# Access Compliance Report

## Public Rights-of-Way

### (Curb Ramps)

Intersection ID: 9711	Main Street: N_DAVIDSON_ST	Cross Street: PATTERSON_ST	Location: SW
ADA ID: 9645C521A978	Ramp Type: Perp	Initial Pass/Fail: Fail	Overall Compliance: No
Severity Score: 1.25			
Codes/Mitigation Info/Possible Solution		Field Measurements/Component Compliance

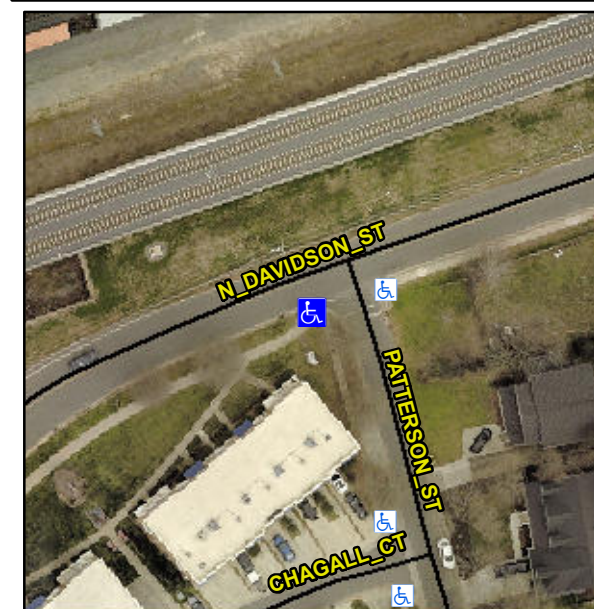
**Not Found, R304.5.3**

Compliance	Description	Data	Compliance	Description	Data
N/A	Ramp Length (in)	49.0	Yes	Ramp Slope (%)	5.6
Yes	Ramp Width (in)	48.0	No	Ramp XSlope (%)	2.7
N/A	Flare Type LT	N/A	N/A	Flare Type RT	N/A
N/A	Flare Slope LT (%)	N/A	N/A	Flare Slope RT (%)	N/A
N/A	Flare Traversable LT?	N/A	N/A	Flare Traversable RT?	N/A
N/A	Landing Length (in)	N/A	N/A	DWS Provided?	N/A
N/A	Landing Width (in)	N/A	N/A	DWS Contrast?	N/A
N/A	Landing Slope (%)	N/A	N/A	DWS Length (in)	N/A
N/A	Landing X Slope (%)	N/A	N/A	DWS Full Width?	N/A
N/A	Landing Curb? (Y/N)	N/A	N/A	DWS Offset (in)	N/A
N/A	Shared Landing?	N/A			
N/A	Gutter Ponding?	N/A	N/A	Gutter Slope (%)	N/A
N/A	Gutter Lip Ht (in)	1.0	N/A	Gutter X Slope (%)	N/A
N/A	Painted X Walk1?	No	N/A	Painted X Walk2?	N/A
	X Walk 1 Direction	To E		X Walk 2 Direction	N/A
N/A	X Walk 1 Width (in)	N/A	N/A	X Walk 2 Width (in)	N/A
	X Walk 1 Slope (%)	0.4		X Walk 2 Slope (%)	N/A
	X Walk 1 X Slope (%)	0.8		X Walk 2 X Slope (%)	N/A

**Remove & Replace Entire Ramp.**
